Product Change Notification

110887 - 00

Change Notification #:	110887 - 00
Change Title:	Intel 10 Gigabit AT2 Server Adapters (Copper Pond AT2 OEM generic/Retail) Intel 10 Gigabit CX4 Dual Port Server Adapters (Cedar Cove OEM generic/Retail) Intel 10 Gigabit XF SR/LR Server Adapters (Bellefontaine OEM generic/Retail) and Intel 10 Gigabit XF SR Dual Port Server Adapters (Green Fountain OEM generic/Retail) PCN 110887-00 Label Updating KCC (Korean Communications Commission) logo to the new KC logo on PB (printed board) and all box labels
Date of Publication:	Aug 05, 2011

New KC logo, Date of Manufacture, Product Identification number, Made in COO (Picture 4, all of the information showing in Picture 4 is for example only and may not reflect actual data)

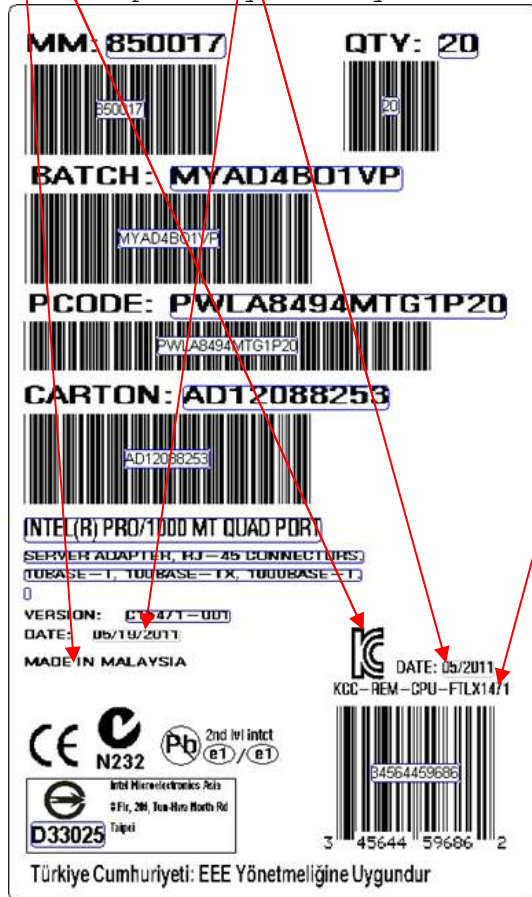
To comply with new regulations from Korea, Intel will be adding the new KC logo to the Printed Board (PB) as a label. The label will be added to either the front or the back of the PB depending on space constraints. The new KC logo will also be added to all box labels (product box label and over-pak box label). **(see pictures 1, 3 & 4)**

Picture 4 showing new KC logo on box label. The box label already contains the Made in Country of Origin (COO) and the Date of Manufacture, this information will also show on the KC label.
